Balboa Park Central Mesa

Precise Plan

Proposed Amendment for
Plaza de Panama, Circulation, and a Parking Structure

April 5, 2012
Sixth Draft

PLAZA DE PANAMA PLAN

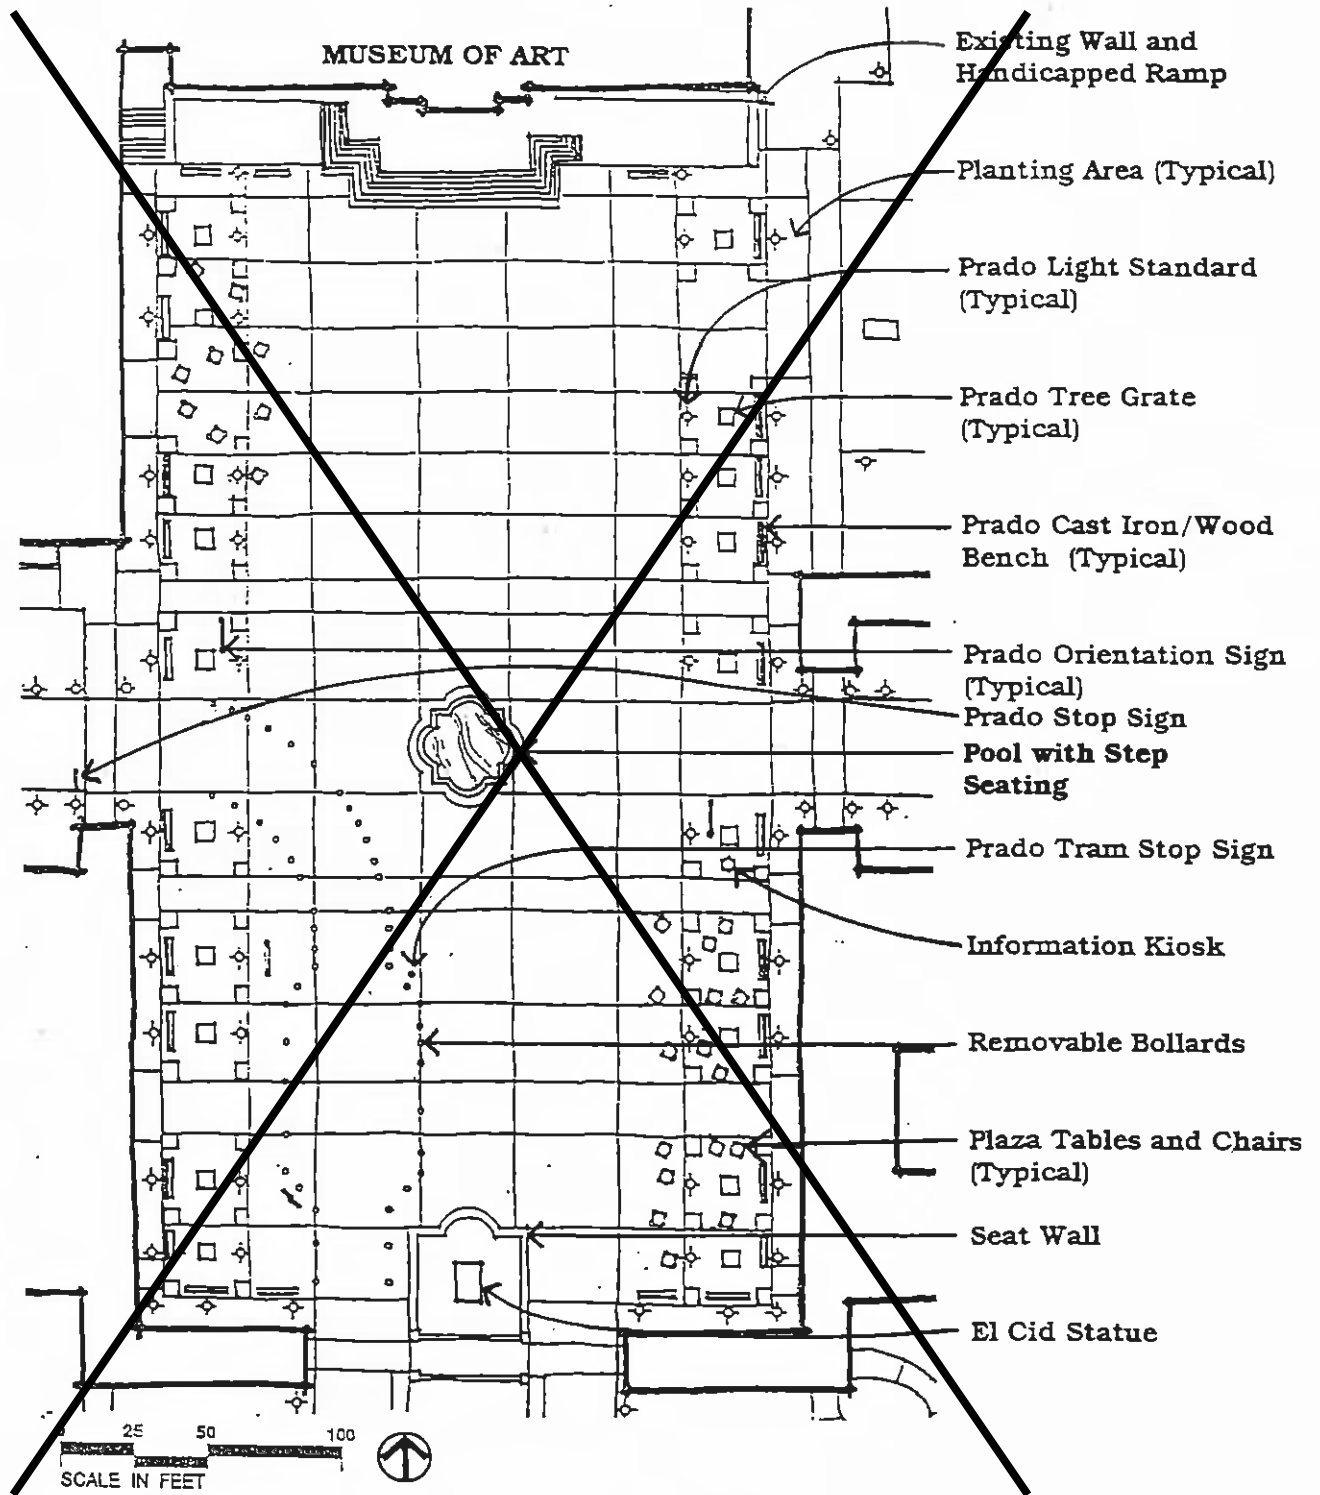
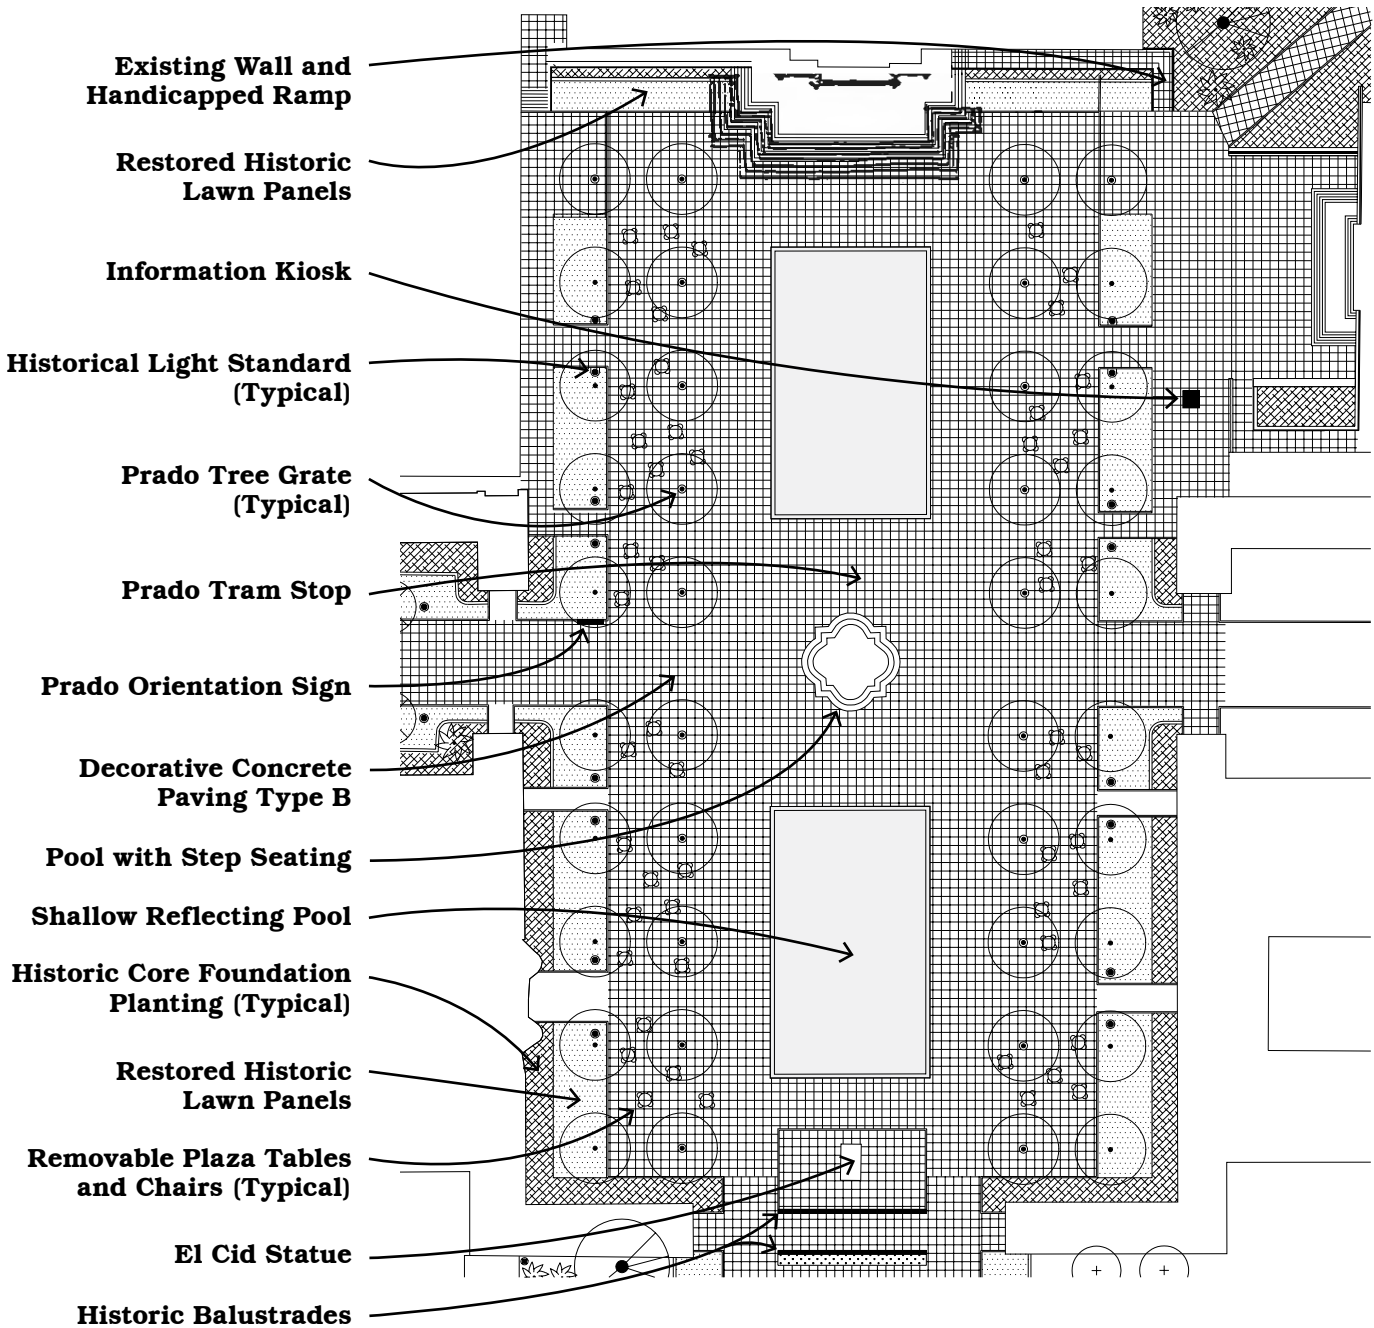
- Place benches along the periphery of the plaza ~~as shown.~~
- Plant bosques of ~~queen palms~~ Plaza de Panama-specific trees at the margins of the plaza.

- Accent the central axial crossing point of the Prado by placing a Spanish Colonial pool in the center of the plaza flanked by shallow reflecting pools to the north and south. ~~Two levels of monumental steps will form the rise to the central pool. These should not exceed 30" in height and be surrounded by a rim that is a minimum of 16" wide to provide seating. Concealed down lights built into the pool steps should be included. Mosaic tiles inside the pool should repeat historic motifs such as the sunburst design found on the tile dome of the California Building. Decorative brass fixtures should also be included inside the pool to support a portable stage deck for special events.~~

- Provide aesthetically pleasing night lighting in the plaza. Features in the Plaza de Panama to highlight will be the trees bosques of palms, the central Spanish Colonial pool, the two reflecting pools, El Cid, and the surrounding arcades and architecture.

- Create two shallow reflecting pools in the plaza, one north and one south of the central Spanish Colonial fountain.
- The pools should have the ability to be deactivated if necessary.
- The depth of the pools should not exceed 1/2” such that when deactivated the surface can be used as part of the plaza space.
- Consider intermittent water jet features to activate the shallow reflecting pools as a play area.
- ~~Locate a seat wall around the statue of El Cid, enclosing seasonal flower beds.~~
- Provide unobtrusive and secure electrical service to support sound and lighting equipment in several areas of the plaza. Provision should also be made for power to be provided to a stage that could be set up over the central fountain.

8. The Mall

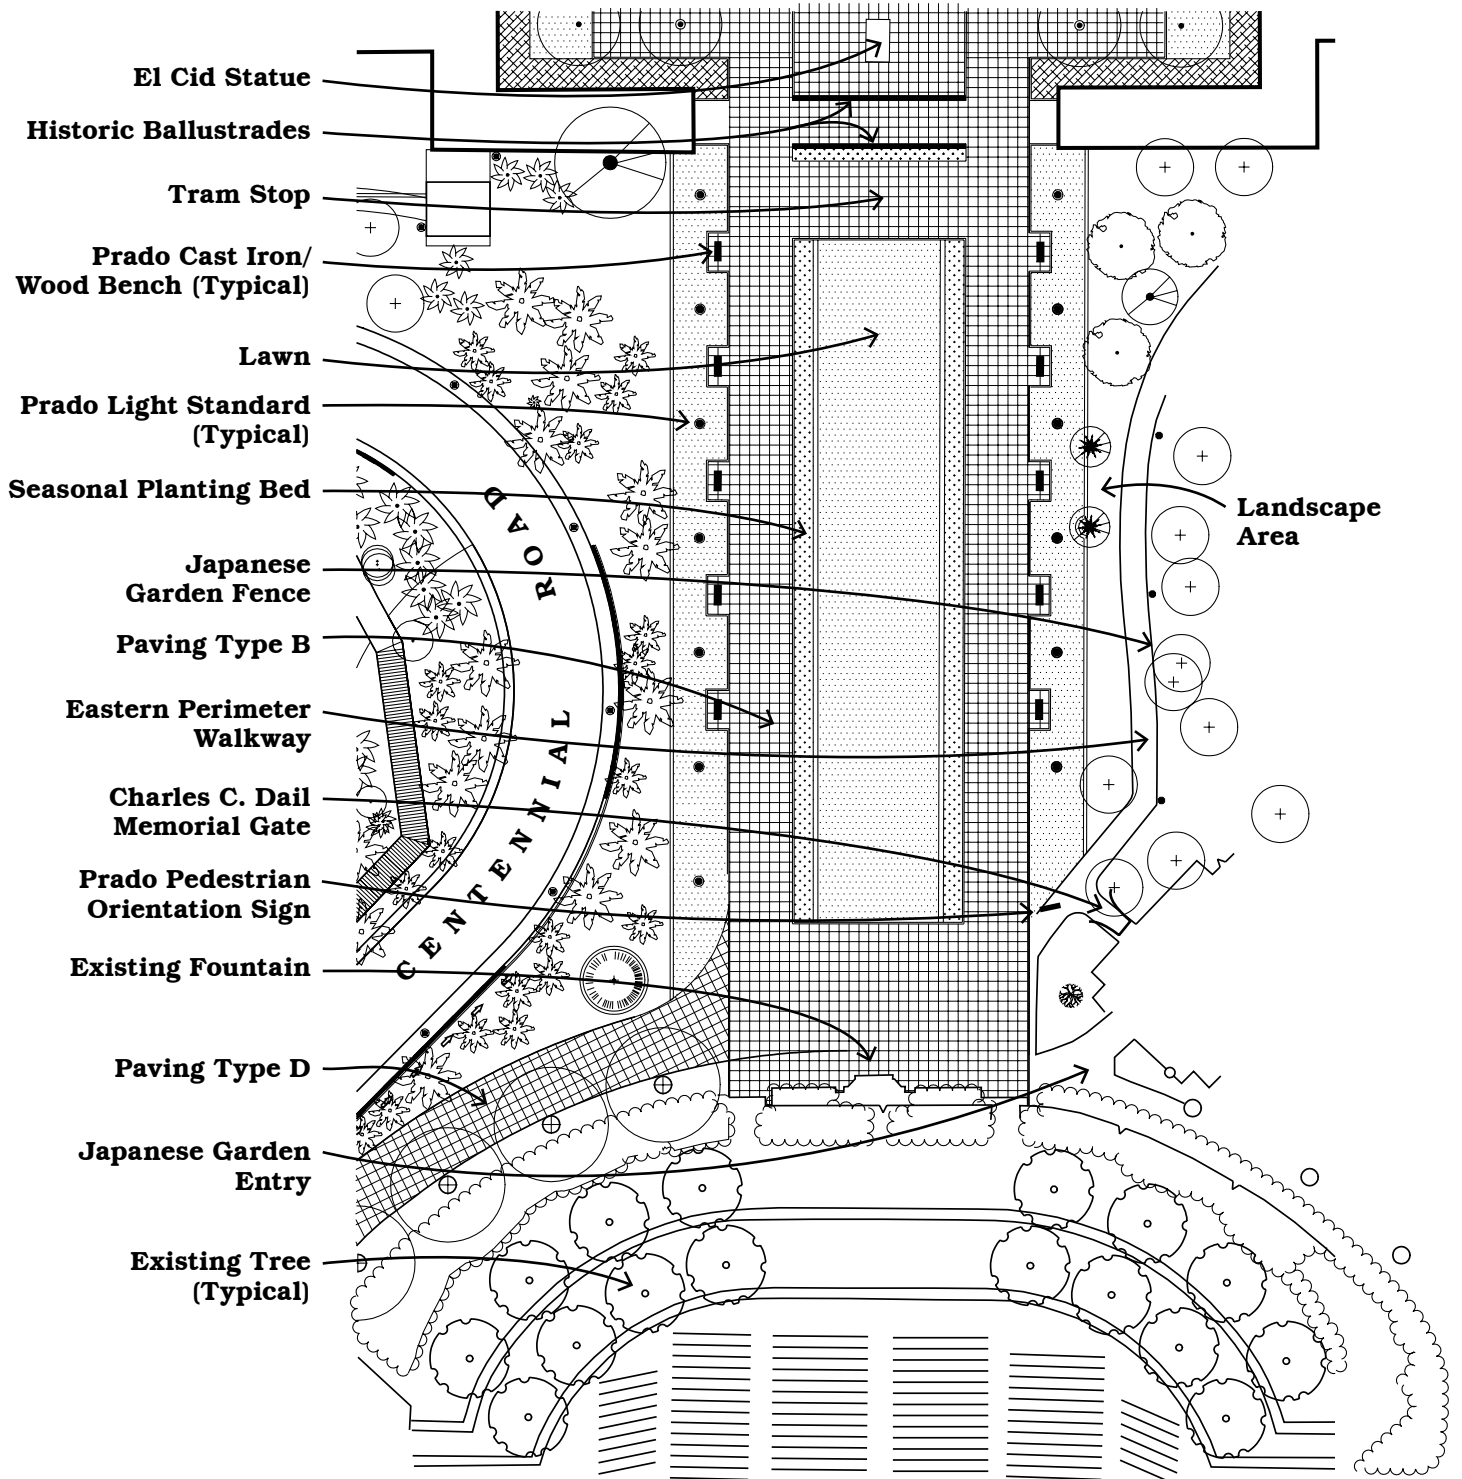
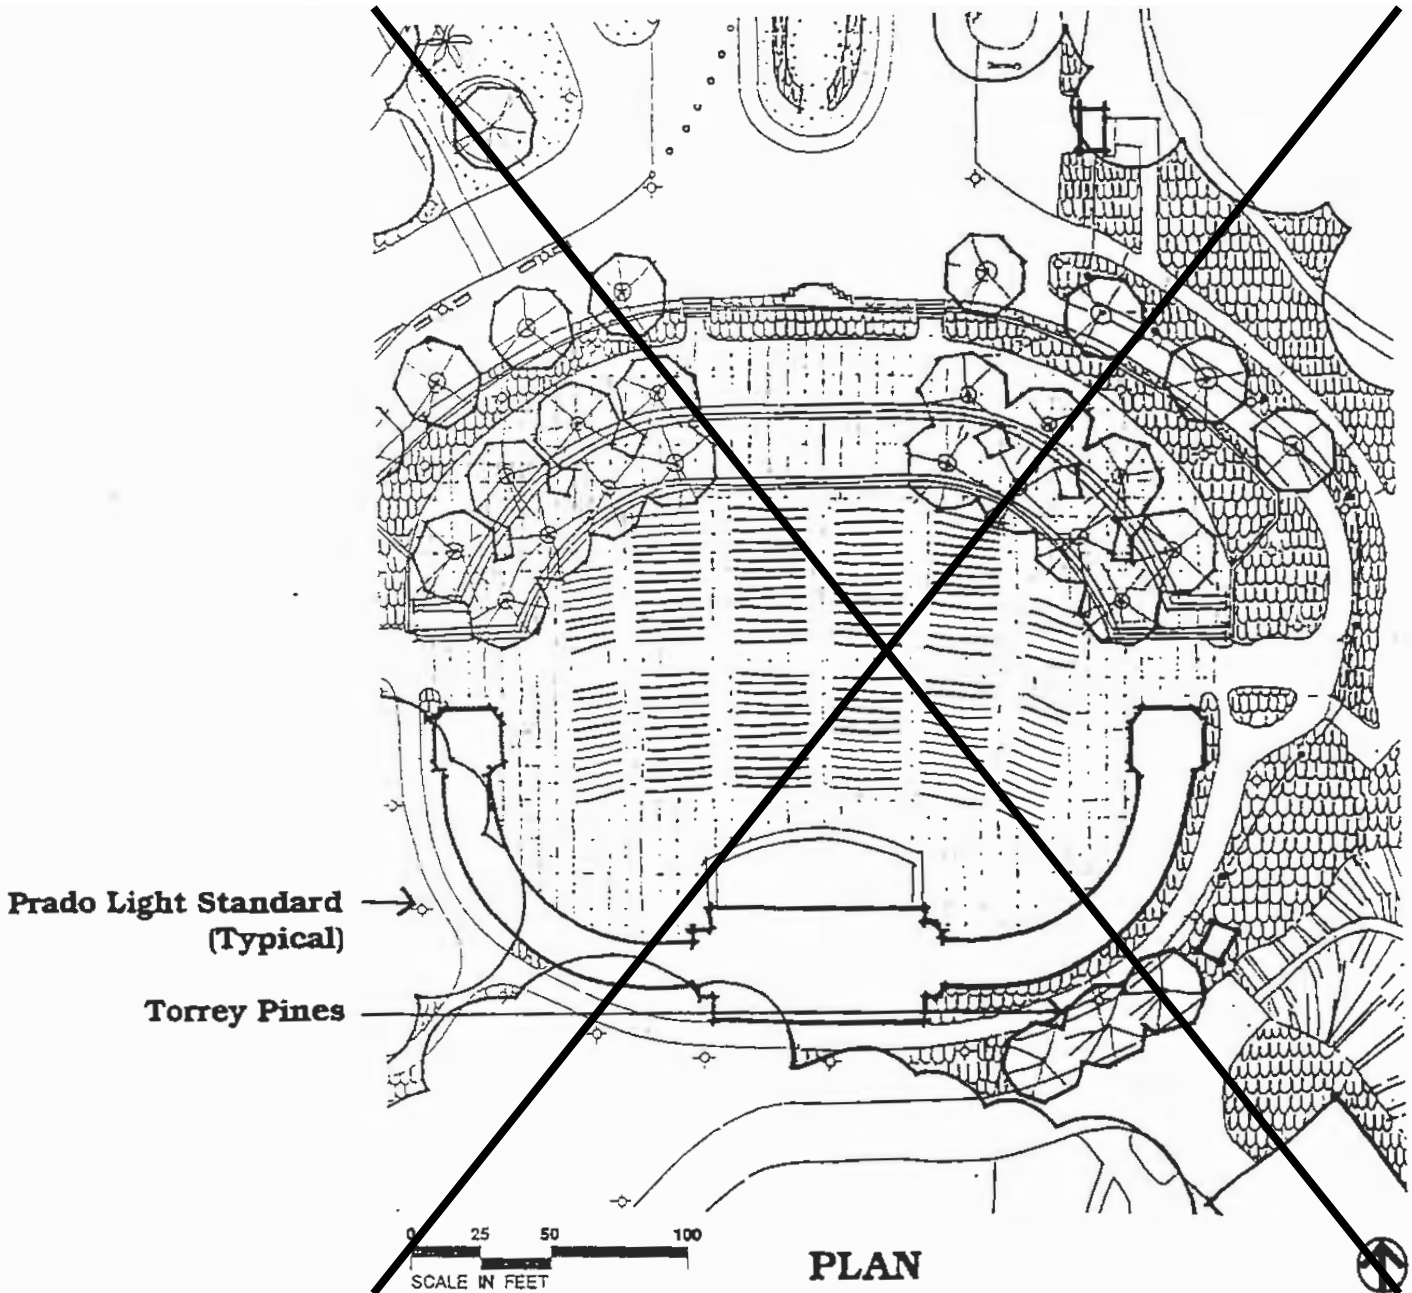
- ~~Retain the existing configuration of the central landscaped area containing lawn and seasonal planting beds.~~
- ~~Border the planting area with a six foot wide type C concrete sidewalk separated from adjacent paving by a six inch curb.~~

- Restore the central landscaped area to its original 1915 proportions.
- Relocate the existing backflow preventer device located in the central landscaped area to a location hidden from public view.

- ~~Separate automobile circulation from pedestrian areas south of the central planting area with bollards that match the Prado light standard bases.~~

- Relocate existing Queen Palms to other locations in the Park to provide an unobstructed view of the Organ Pavilion from the Plaza de Panama and reintroduce a row of Mall-specific deciduous trees along the east and west edges of the space to emphasize the Mall as an important physical and visual axis between the Organ Pavilion and the Plaza de Panama.
